Toll Bridge Seismic Retrofit and Regional Measure 1 Programs

Independent Cost Estimate Review
San Francisco – Oakland Bay Bridge
Contract No. 04-012024
The Skyway - Orthotropic Box Girder (KFM/USI)

Preliminary Draft Issue – August 07

Figure 1 State Interpretation of Weld Spec

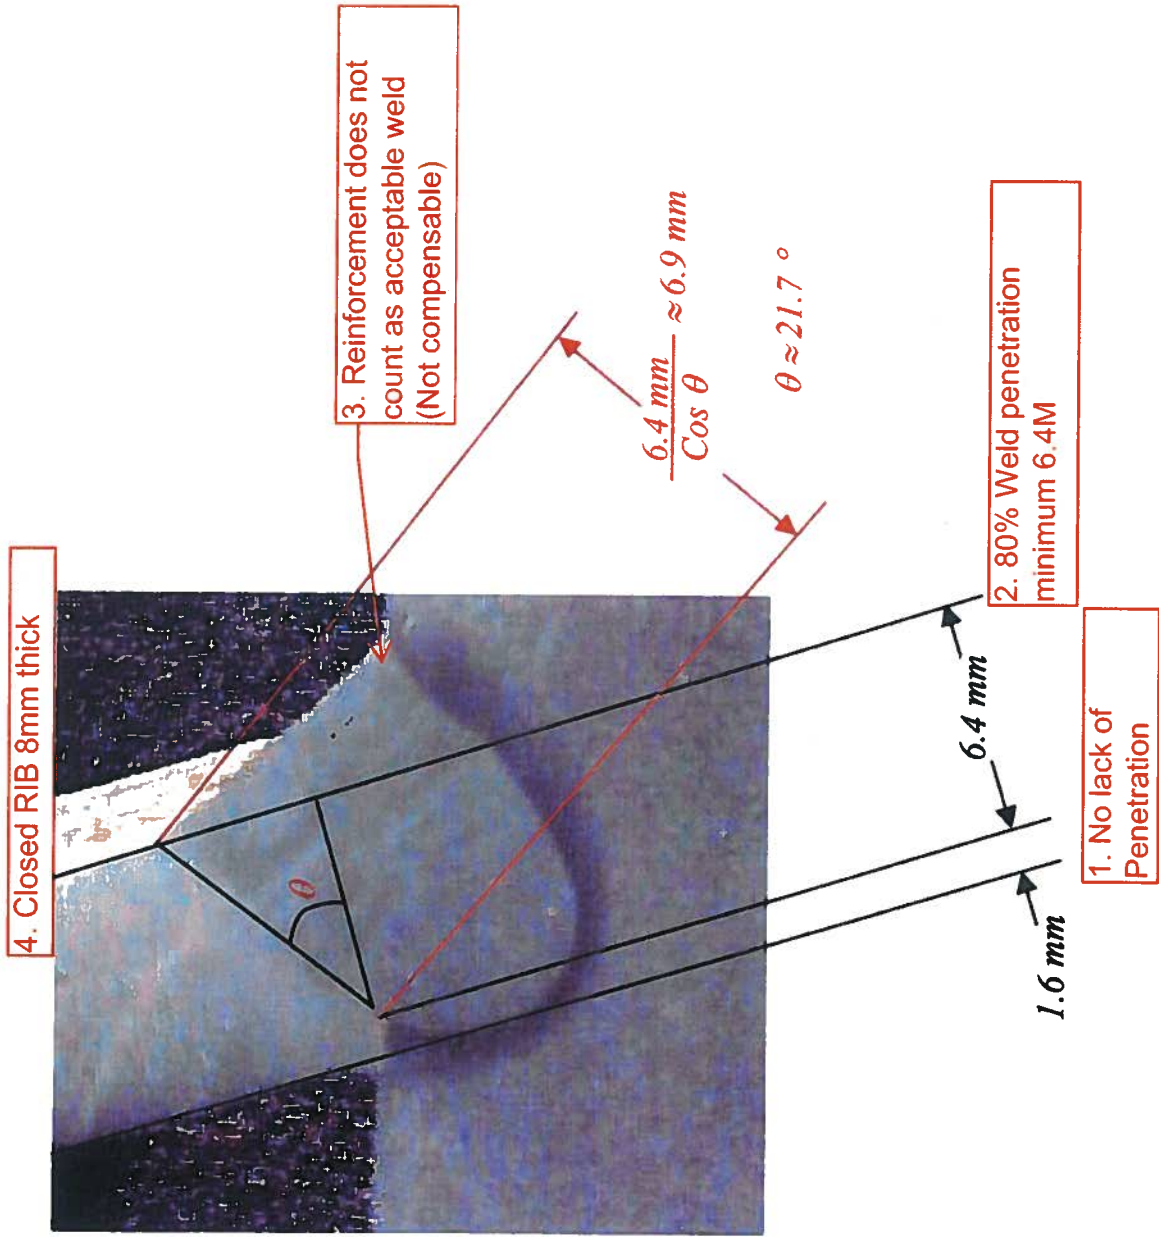
BAMC finds that ambiguity existed with the contract specification and AWS D1.5 allows a weld reinforcement up to a certain size. Therefore, the state's position for weld measurement to exclude payment for the weld reinforcement is not reasonable. (See figures 1 and 2 at the end of this report.) BAMC recommends that the contractor be compensated reasonably for his costs related to approval of these welds.

- 80% penetration of the nominal thickness of rib: $0.8(8) = 6.4$ mm
- LOP greater than 1.6 mm is not allowed
- Contract does not specify a reinforcement fillet weld
- Contract permits a 0-3 mm reinforcement fillet due to normal variations in welding

Figure 2 Contractor Interpretation Weld Spec

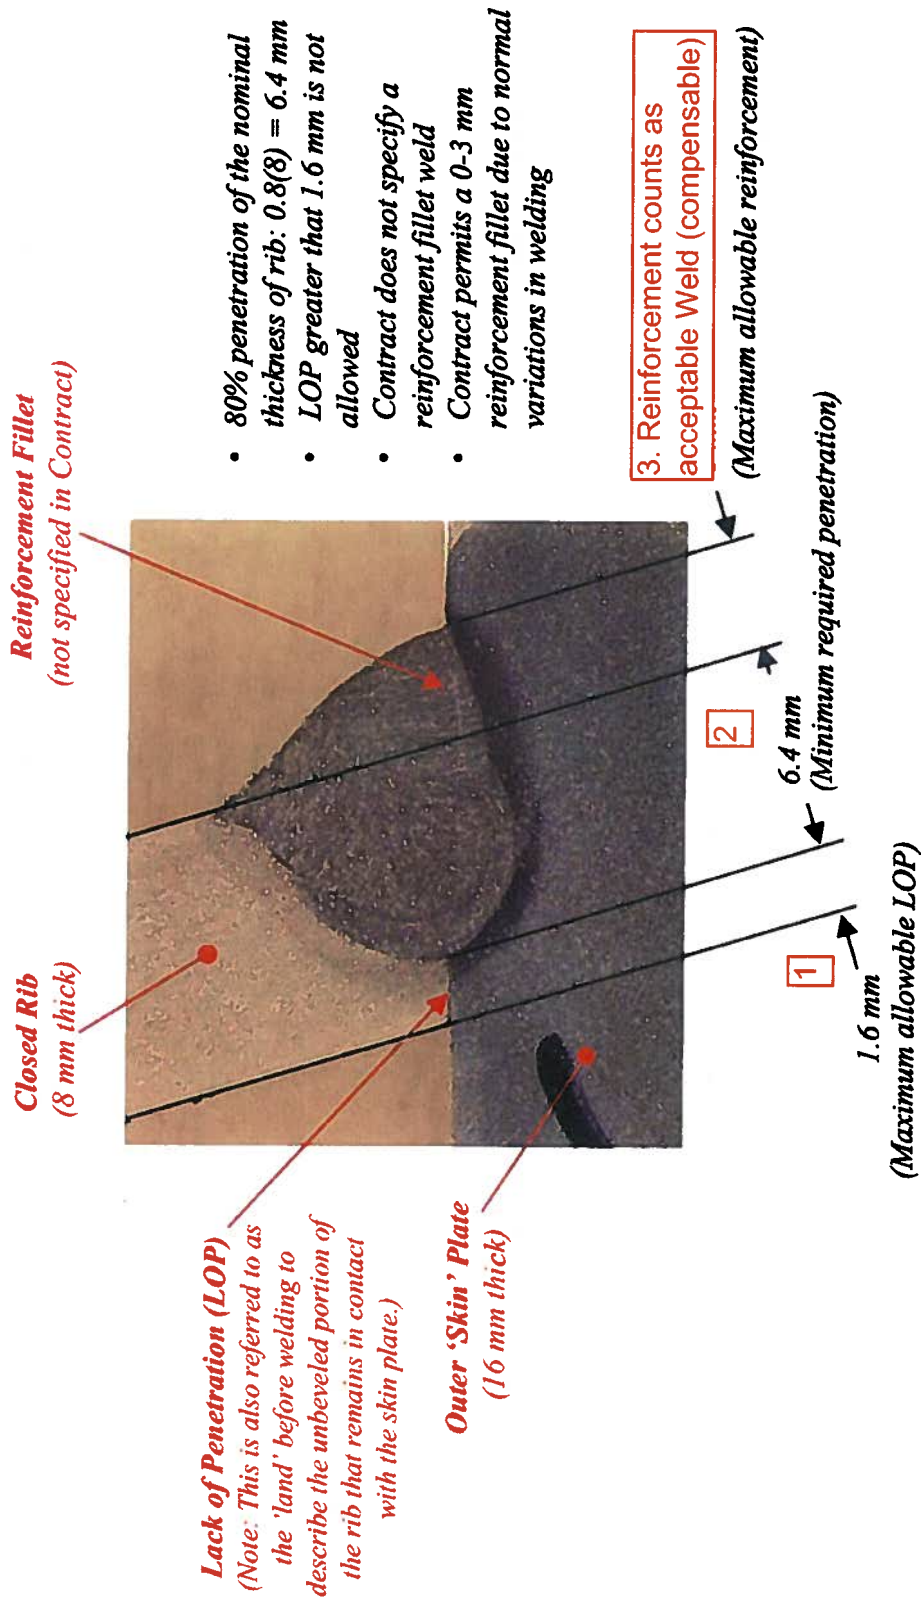
The dispute is a question as to how the effective weld size of the closed rib to plate weld is to be measured. USI contends that AWS D1.5-1996, (AWS D1.5) which is a supplementary contract document, requires the reinforcing fillet weld to be included in the weld size measurement while the Department contends that the weld reinforcement is to be excluded from the weld size measurement. Basically USI wants to measure the weld including the reinforcing fillet per AWS D1.5 for a combination partial joint penetration groove weld and a fillet weld and the State wants to achieve joint penetration equal to 80% of the rib thickness and do not accept that the PJP weld is a combination weld.

The Contractor’s main basis for the claim appears to rest on their interpretation of AWS’ definition of ‘Weld Size’. The definition adopted is quoted from clause 2.3.4 which relates to “The effective weld size of a combination partial joint penetration groove weld and a fillet weld”. The State however maintains that the weld in question is a partial joint penetration groove weld and on this basis the correct definition of the effective weld size is defined within clause 2.3.1.3. Section 2 of AWS D1.5 relates to the design of welds and the term ‘effective weld size’ is used throughout apart from in 2.1.3 where it states that “Contract design drawings shall specify the effective weld length and, for partial penetration groove welds, the required weld size, as defined in 2.3.” Within Annex V of AWS D1.5, the term ‘weld size’ is defined for a fillet weld and for a groove weld. The definition for ‘groove weld size’ is “The joint penetration of a groove weld”, the definition of ‘joint penetration’ is “The distance the weld metal extends from the weld face into a joint, exclusive of reinforcement”. The drawing referenced, details a PJP but there is no call up requiring a reinforcing fillet.

Figure 3 Measurement Criteria

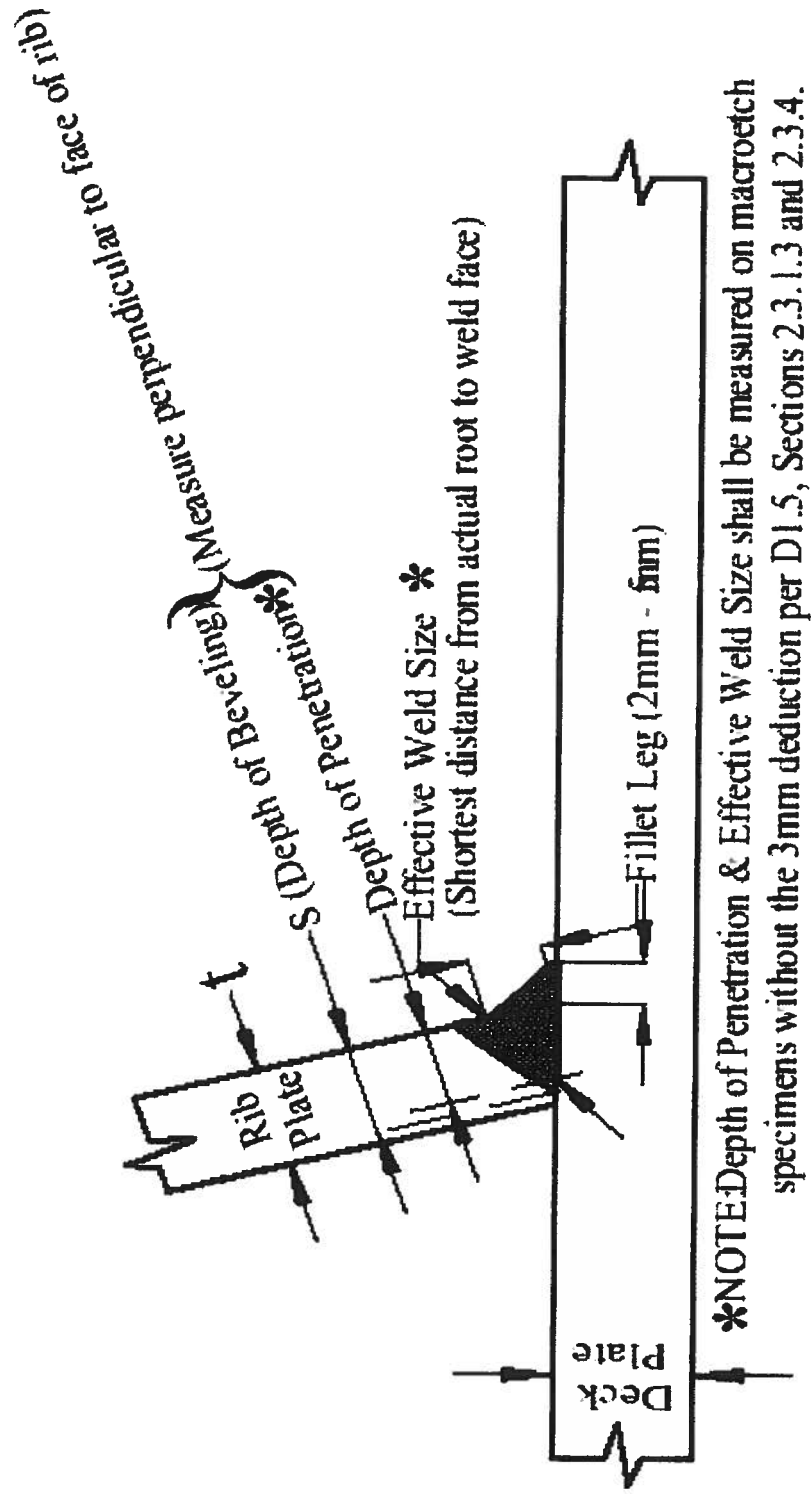
Contractor. There is discrepancy and ambiguity within AWS D1.5 1996, which raises questions as to the weld size specified on the Contract drawing. However, we maintain that the intent of the specification and the drawing is that a PJP shall be provided, its size has been clarified via response to RFI's as being as that defined within Annex V of D1.5.

On page 8 of the Contractor's paper the weld size (6) is stated as being the "effective weld size" but this definition appears to have been adopted from the 2002 version of AWS. It should however be noted that the drawings in question were produced in 2000 and 2001 and would therefore have been prepared in accordance with AWS D1.5:1996.
